KICKS 66 CONVENIENCE STORE
GAS STATION WITH CARWASH
1200 WYCLIFFE NE, ALBUQUERQUE, NM
PROJECT 2014

GRADING AND DRAINAGE PLAN

CONVENIENCE STORE & GAS STATION w/ CARWASH FOR LOUIS HERRERA GRADING & DRAINAGE PLAN

CONVENIENCE STORE & GAS STATION w/ CARWASH FOR LOUIS HERRERA GRADING & DRAINAGE PLAN

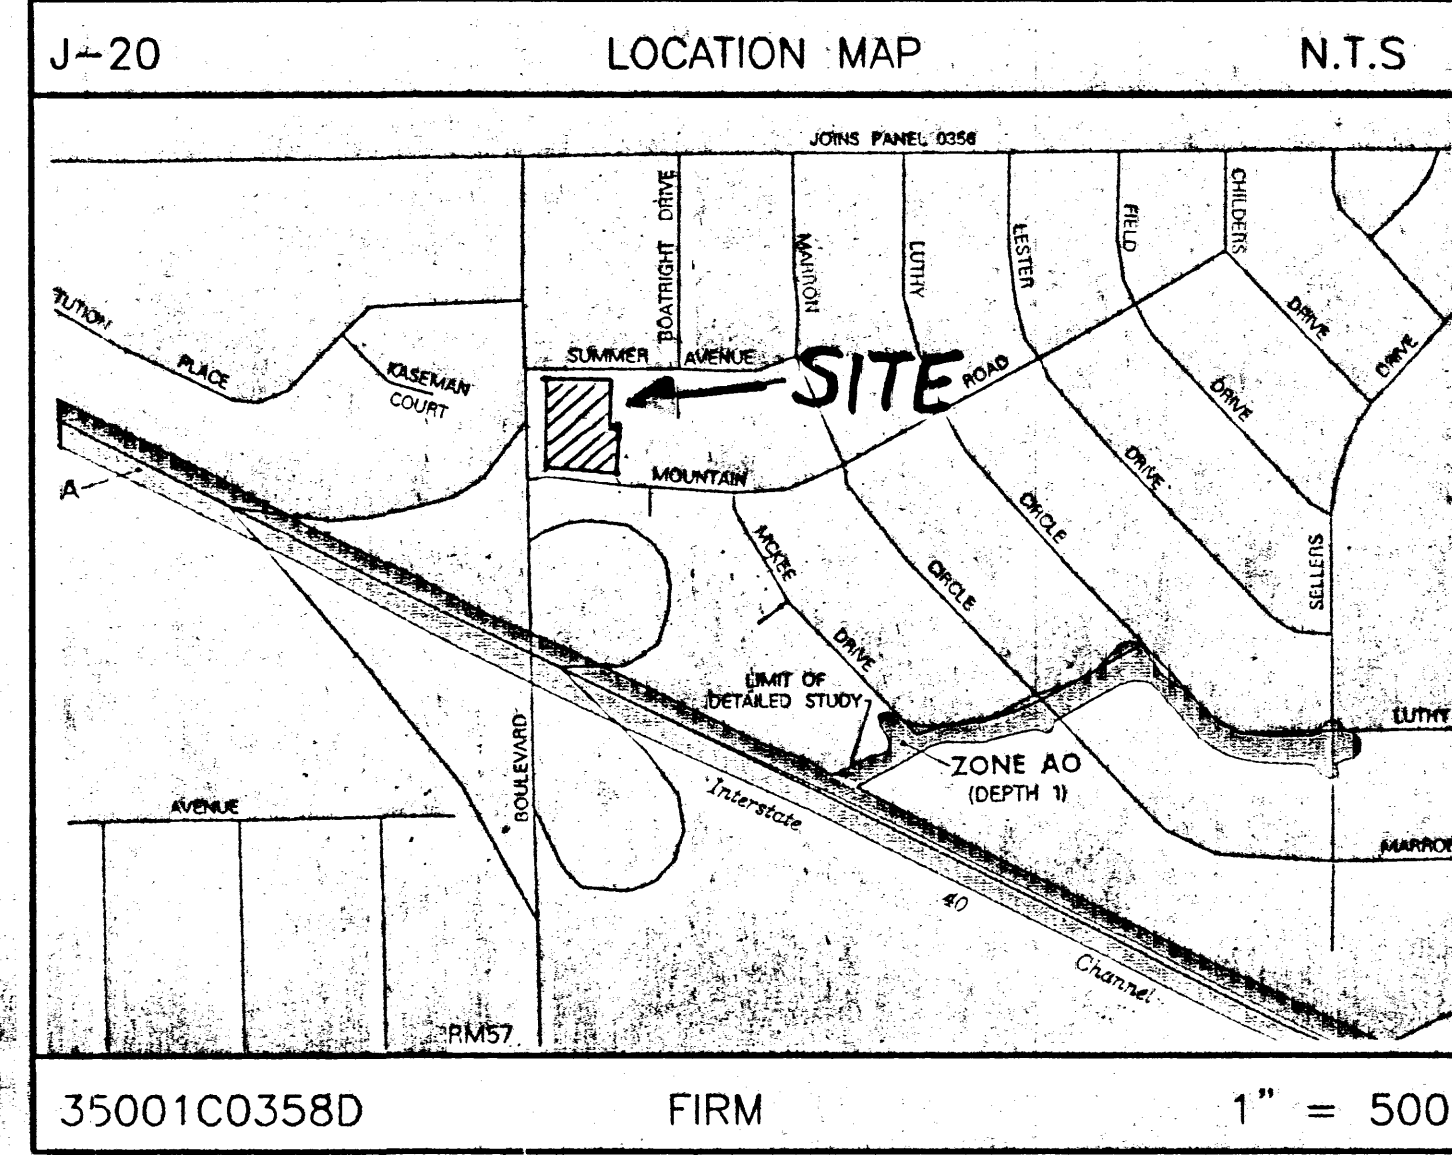
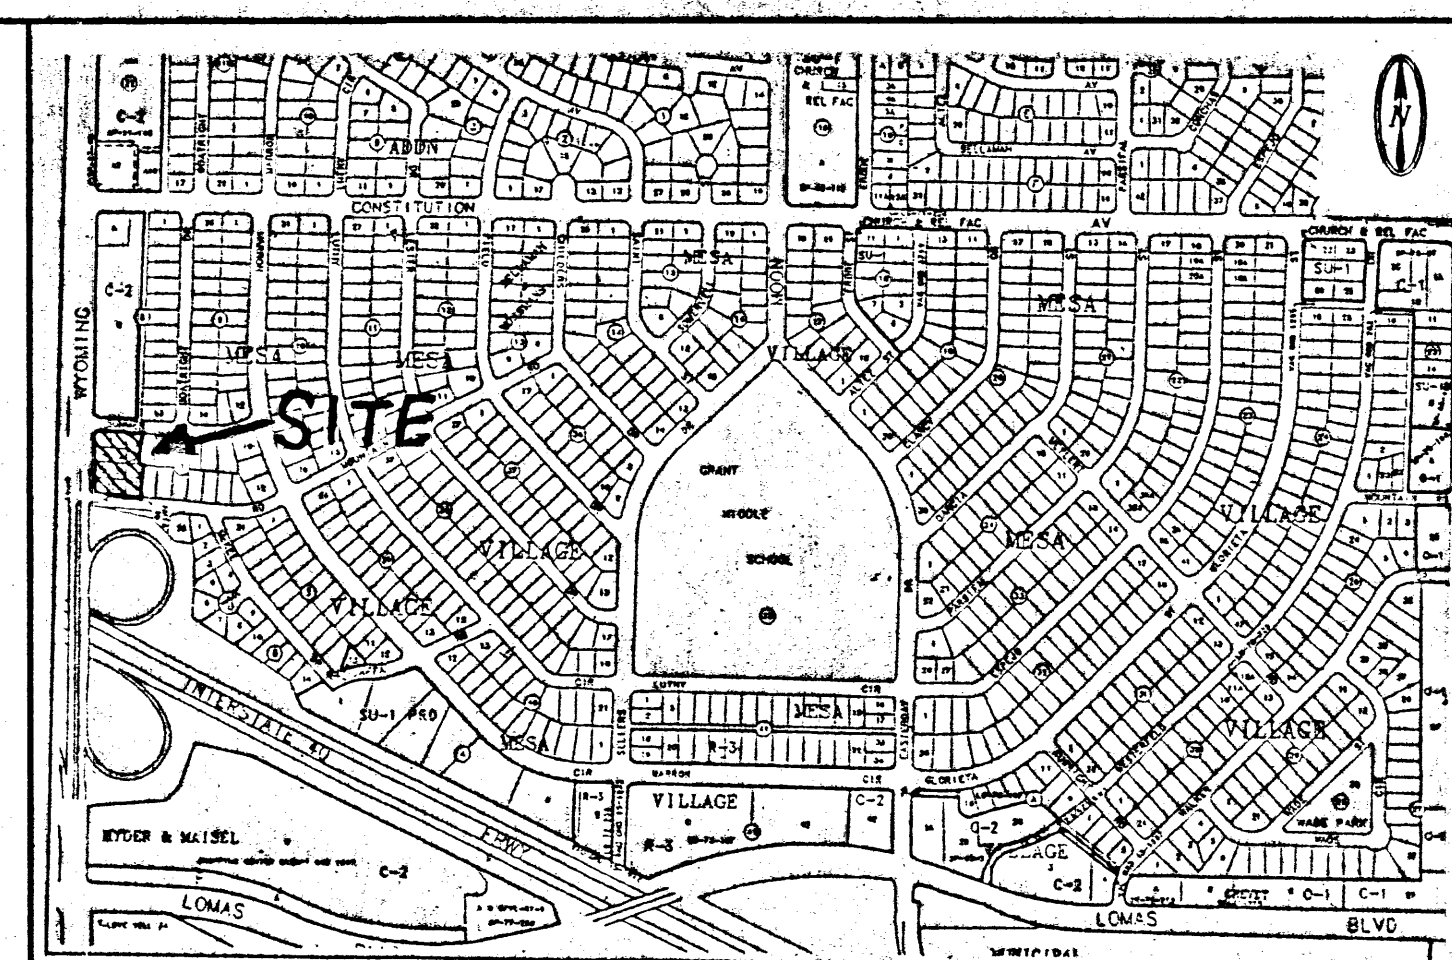
UNDEVELOPED AREA (AC) MUST = DEVELOPED AREA (AC) PROPOSED

IF NO OFFSITE FLOW, PLEASE STATE AS SUCH ON PLAN.

WHAT IS THIS OK PLAN TO DO THIS SECTION VISIBLE

SITE PLAN
1"=20'

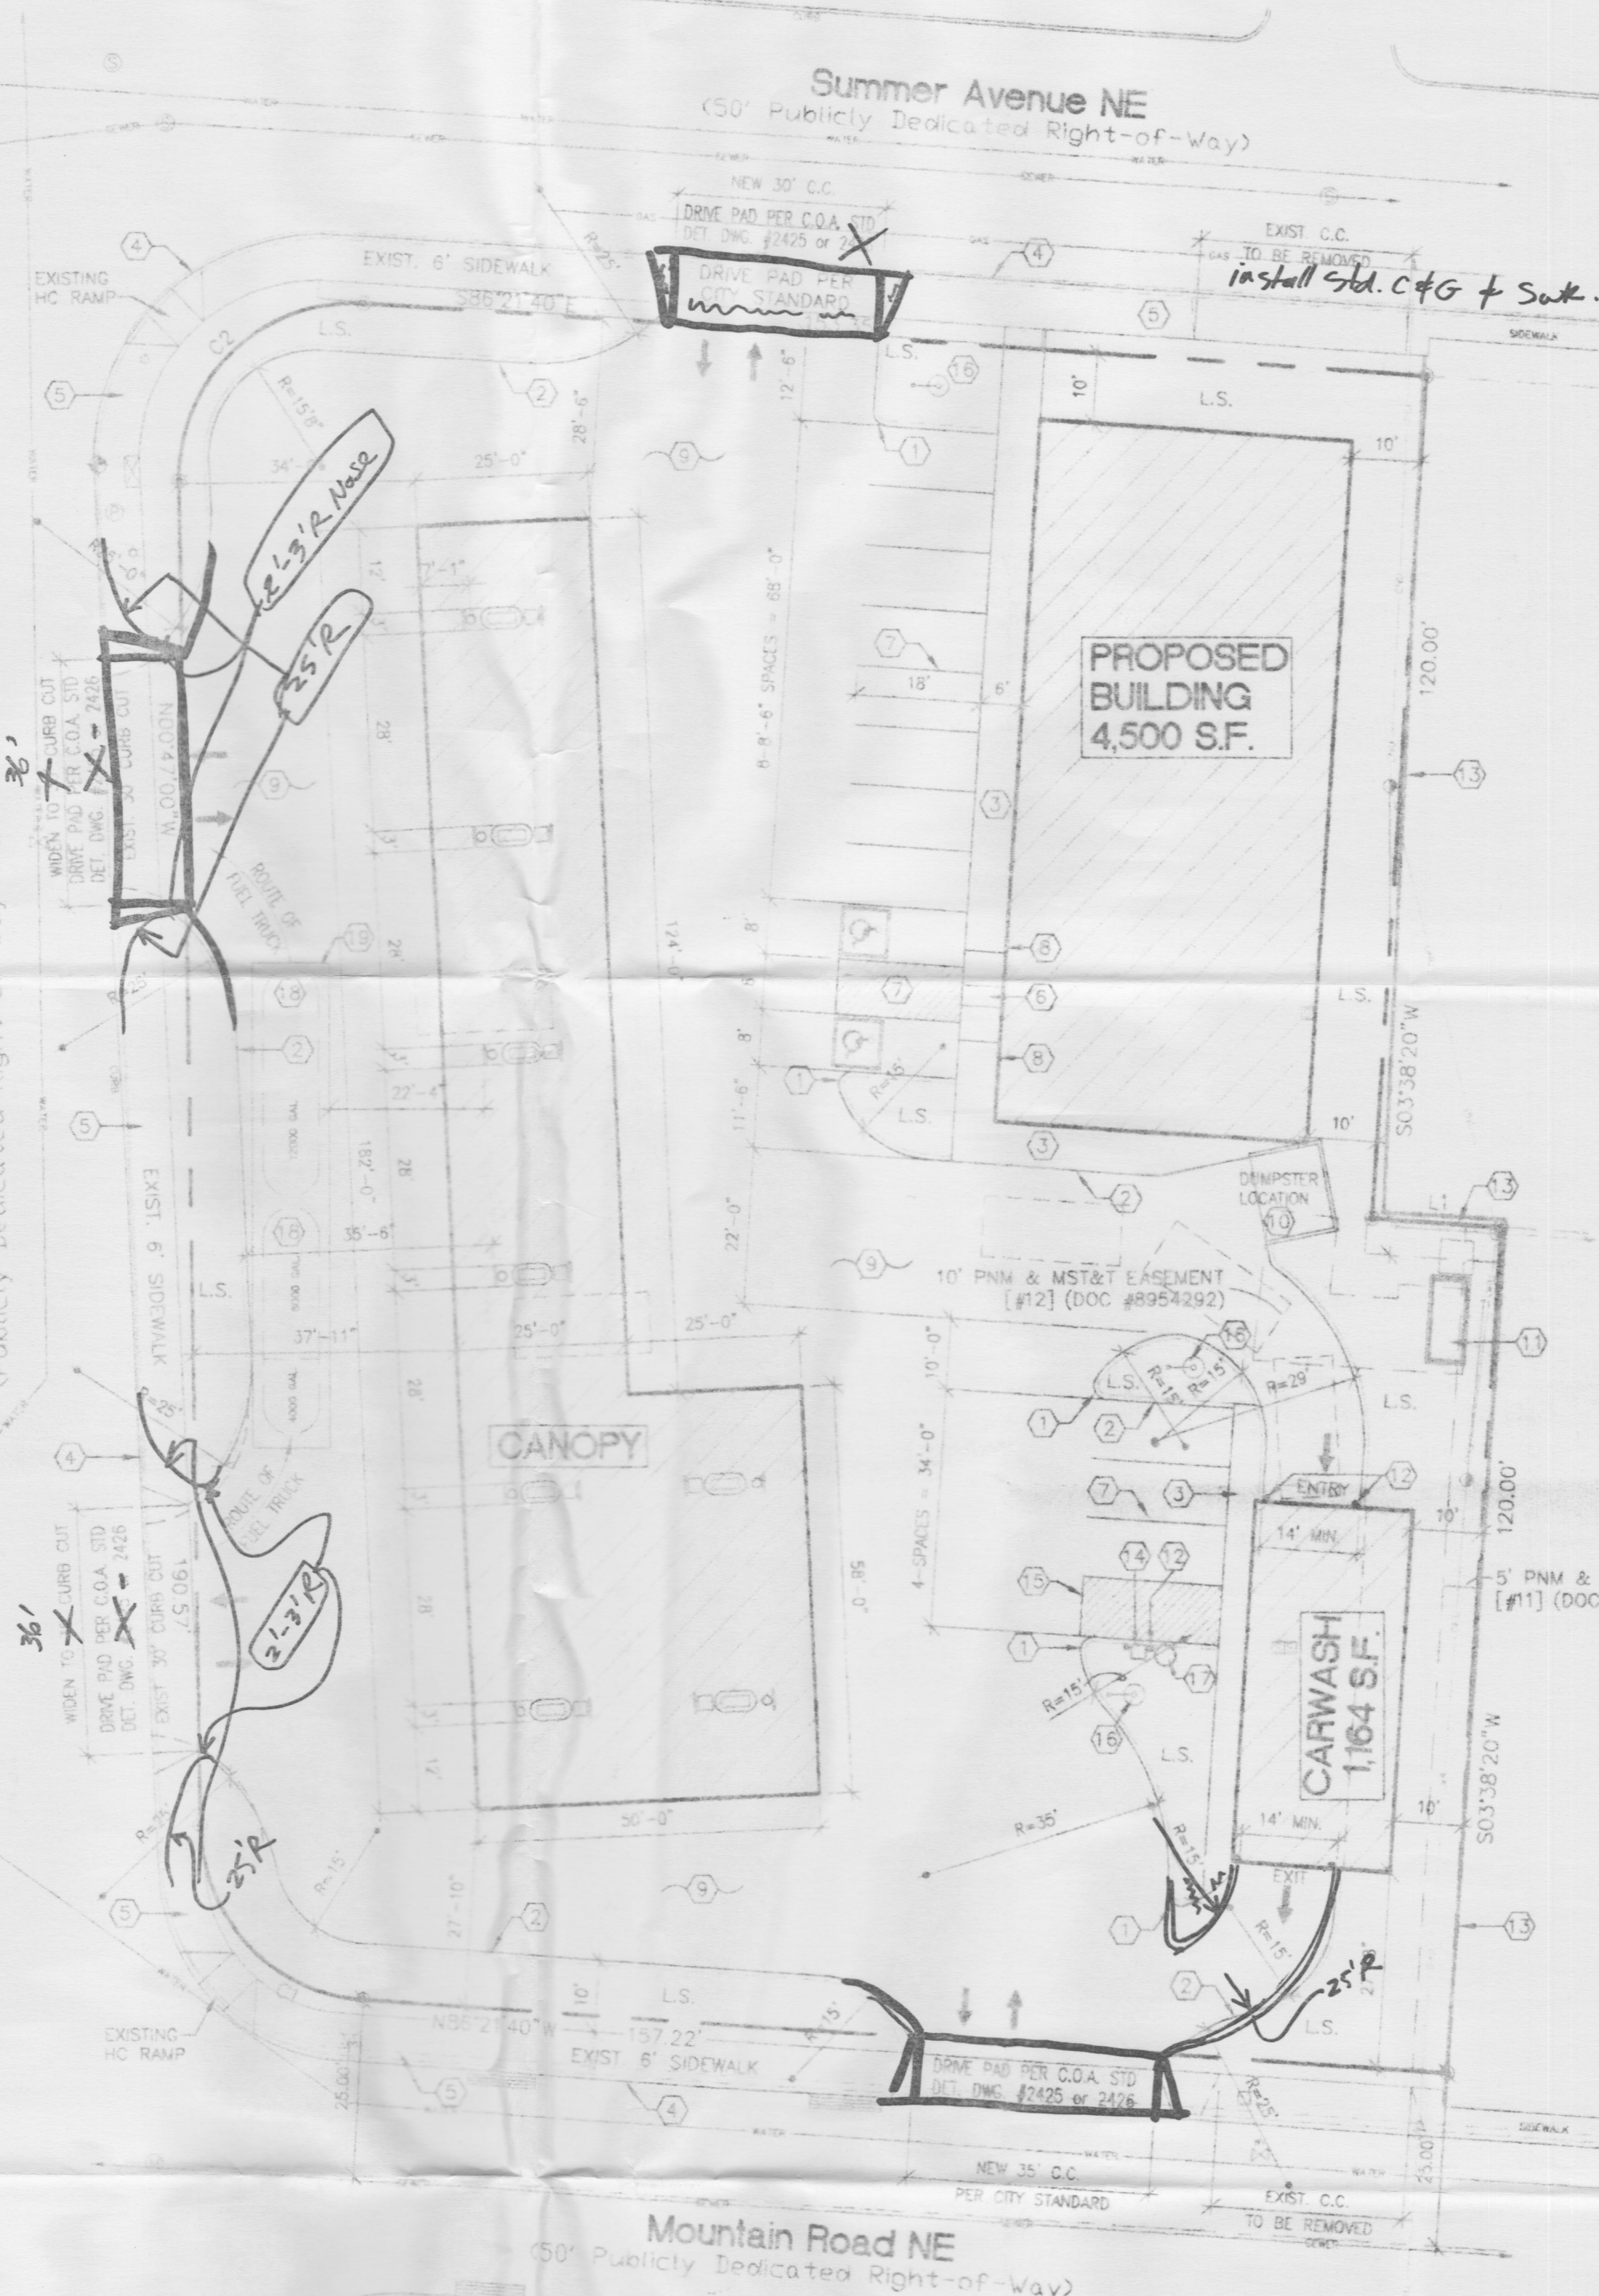
is sidewalk const. in addition to curbing in front of Bldg. if so show curb line on callout type of sidewalk and trail, turn down type?
